# Access Compliance Report

## Public Rights-of-Way

### (Curb Ramps)

Intersection ID: 49348	Main Street: HONEY_FIG_RD	Cross Street: FIRESPIKE_RD	Location: SE
ADA ID: F31FF5C89EA2	Ramp Type: Perp	Initial Pass/Fail: Fail	Overall Compliance: No
Severity Score: 8.75			
Codes/Mitigation Info/Possible Solution		Field Measurements/Component Compliance

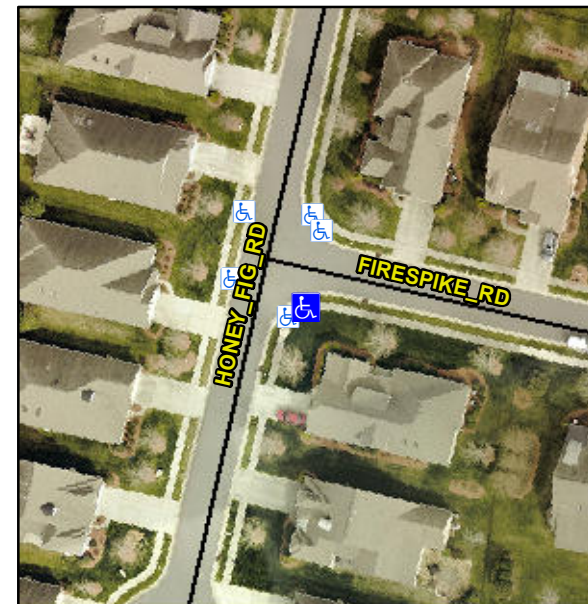
**R304.5.1**

Compliance	Description	Data	Compliance	Description	Data
N/A	Ramp Length (in)	47.0	Yes	Ramp Slope (%)	6.1
No	Ramp Width (in)	47.0	Yes	Ramp XSlope (%)	0.8
N/A	Flare Type LT	N/A	N/A	Flare Type RT	N/A
N/A	Flare Slope LT (%)	N/A	N/A	Flare Slope RT (%)	N/A
N/A	Flare Traversable LT?	N/A	N/A	Flare Traversable RT?	N/A
N/A	Landing Length (in)	N/A	N/A	DWS Provided?	N/A
N/A	Landing Width (in)	N/A	N/A	DWS Contrast?	N/A
N/A	Landing Slope (%)	N/A	N/A	DWS Length (in)	N/A
N/A	Landing X Slope (%)	N/A	N/A	DWS Full Width?	N/A
N/A	Landing Curb? (Y/N)	N/A	N/A	DWS Offset (in)	N/A
N/A	Shared Landing?	N/A			
N/A	Gutter Ponding?	N/A	N/A	Gutter Slope (%)	N/A
N/A	Gutter Lip Ht (in)	N/A	N/A	Gutter X Slope (%)	N/A
N/A	Painted X Walk1?	No	N/A	Painted X Walk2?	N/A
	X Walk 1 Direction	To NE		X Walk 2 Direction	N/A
N/A	X Walk 1 Width (in)	N/A	N/A	X Walk 2 Width (in)	N/A
	X Walk 1 Slope (%)	2.1		X Walk 2 Slope (%)	N/A
	X Walk 1 X Slope (%)	0.3		X Walk 2 X Slope (%)	N/A

**Remove & Replace Entire Ramp.**
